AURORA 310 DEVELOPMENT. 56TH AVENUE, (PICADILLY TO E470)
INFRASTRUCTURE SITE PLAN

56TH AVENUE (PICADILLY ROAD TO E470) IMPROVEMENT SITE PLAN

Date	Submission / Revision
02/04/2025	1ST COA SUBMITTAL

SITE PLAN

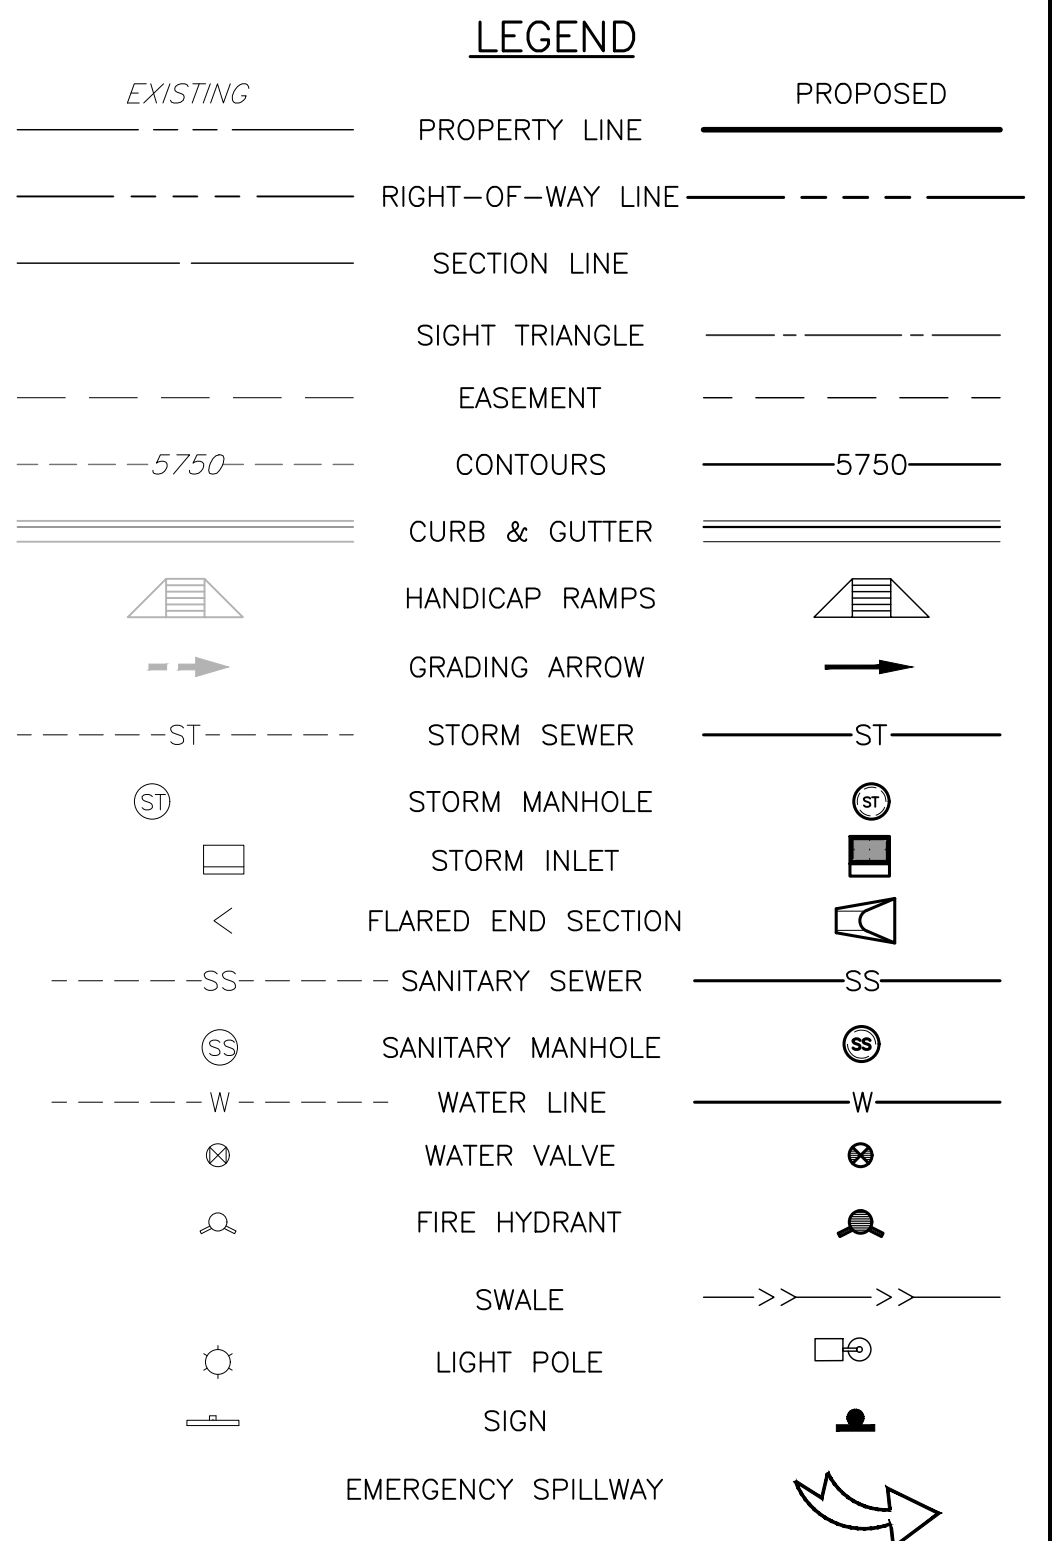
Add recording numbers for subdivisions (Typical).

is this ROW?
Also, may be
city boundary

SITE PLAN

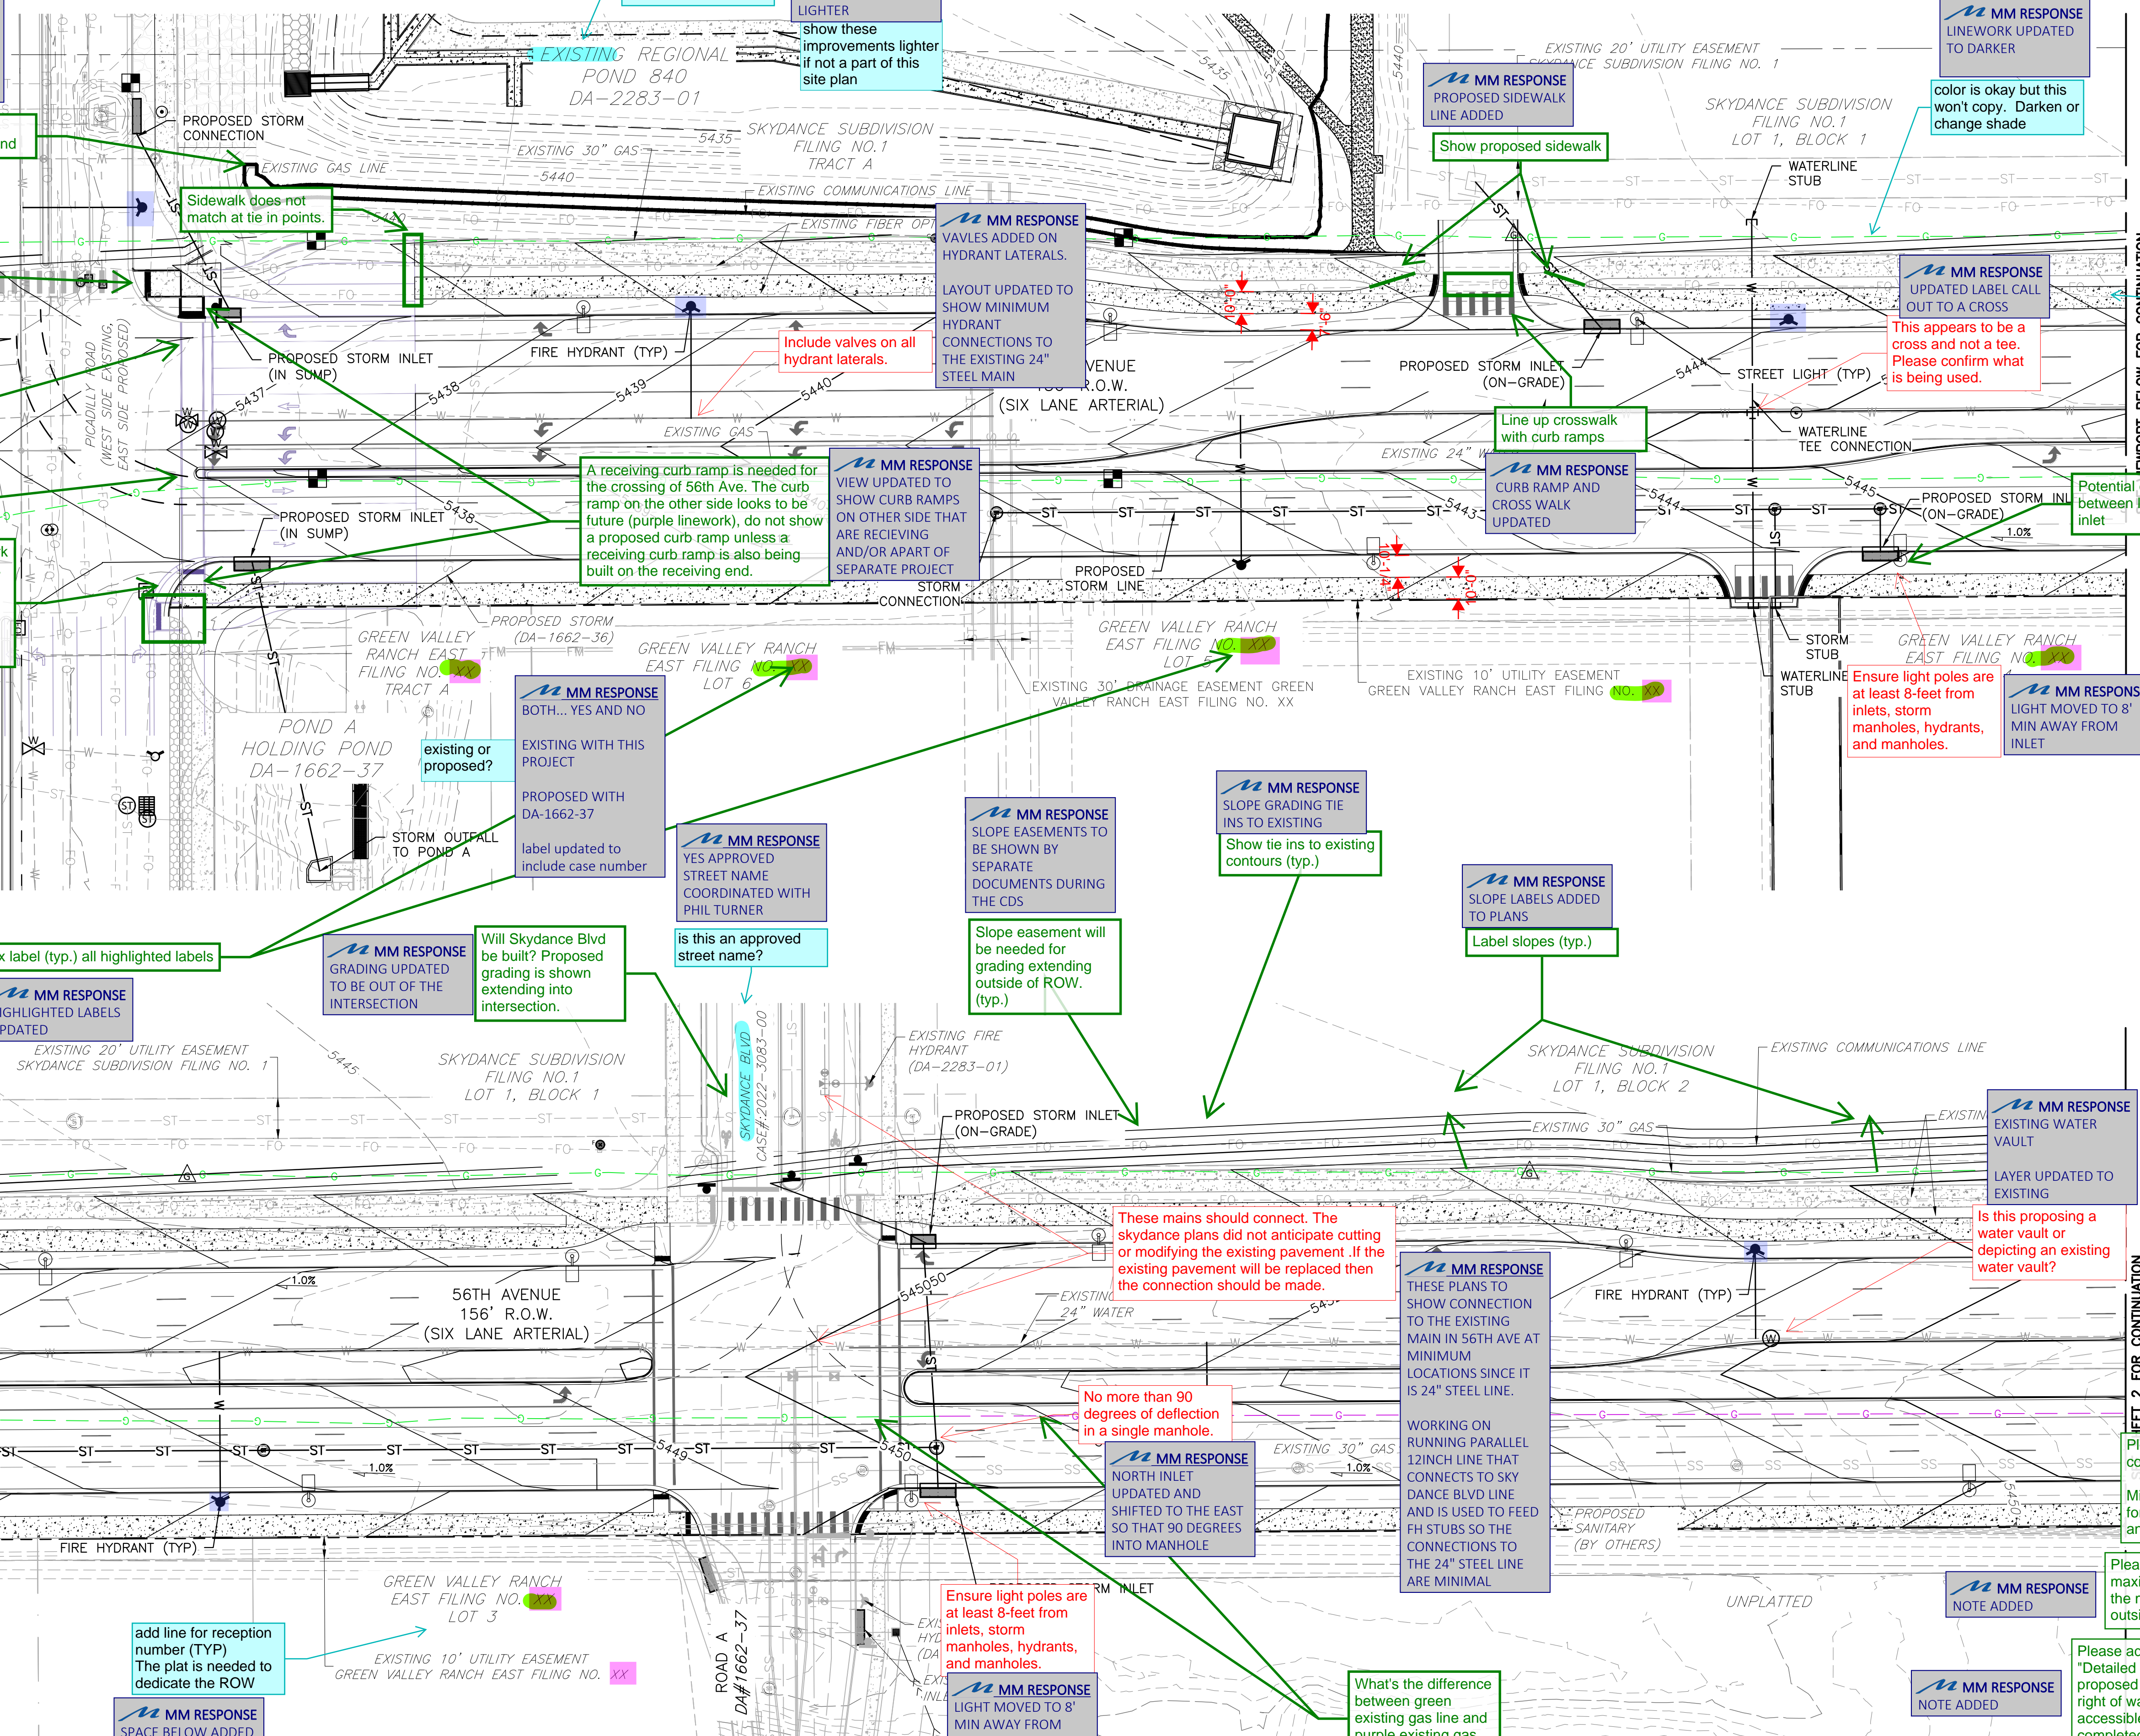
or proposed? Add
name of site plan and
case number

MM RESPONSE
LINEWORK THAT IS
PART OF SEPARATE
SITE PLANS MADE
LIGHTER
show these
improvements lighter
if not a part of this
site plan

Add recording numbers for
subdivisions (Typical).

EXISTING	PROPOSED
MM RESPONSE CONCRETE HATCH ADDED TO ALL LEGENDS	PROPERTY LINE
concrete? add to legend. TYP all symbols	RIGHT-OF-WAY LINE
	SECTION LINE
	SIGHT TRIANGLE
	EASEMENT
	CONTOURS
	CURB & GUTTER
	HANDICAP RAMPS
	GRADING ARROW
	STORM SEWER
	STORM MANHOLE
	STORM INLET
	FLARED END SECTION
	SANITARY SEWER
	SANITARY MANHOLE
	WATER LINE
	WATER VALVE
	FIRE HYDRANT
	SWALE
	LIGHT POLE
	SIGN
	EMERGENCY SPILLWAY

MM RESPONSE
EXISTING, CASE
NUMBER FROM SKY
DANCE PHASE 1 POND
ADDED

MM RESPONSE
KNOWN RECORDING
LABELS ADDED AND
REMOVE LEFT FOR
RECEPTION NUMBERS
OF PLATS THAT ARE
CURRENTLY UNDER
REVIEW OR CLOSE TO
BEING RECORDED

Design Project No. 24.1527
Drawing Title
**GRADING
AND UTILITY
PLAN**

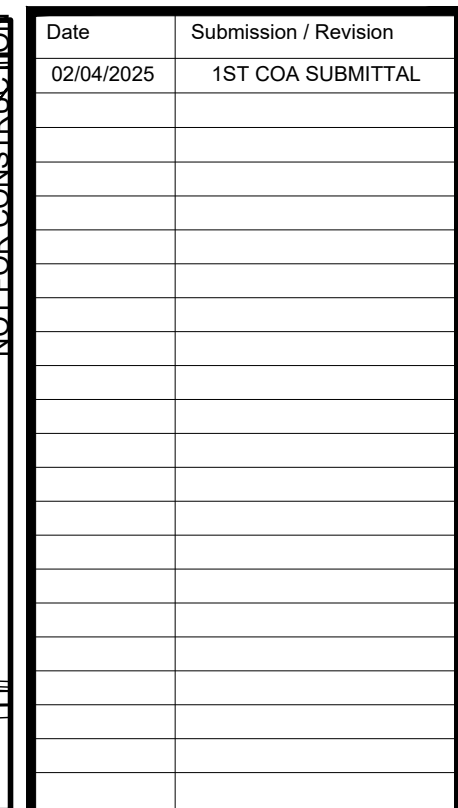
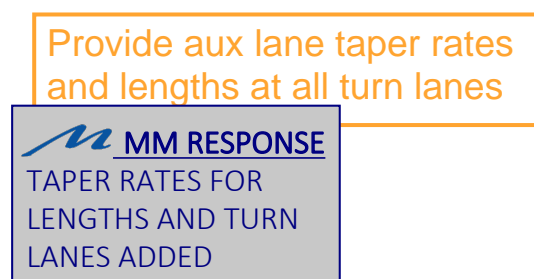
Please add the following
comments:
Minimum pavement slopes: 1%
for asphalt, 0.5% for concrete,
and 2% for landscaping.

Please add the following note: "The
maximum slope within ROW is 4:1,
the maximum slope for property
outside of the ROW is 3:1."

Please add the following note:
"Detailed layout and design for
proposed curb ramps within
right of way or along an
accessible route will be
completed with the civil plans."

Add "PLAN" to match previous 2 sheets.
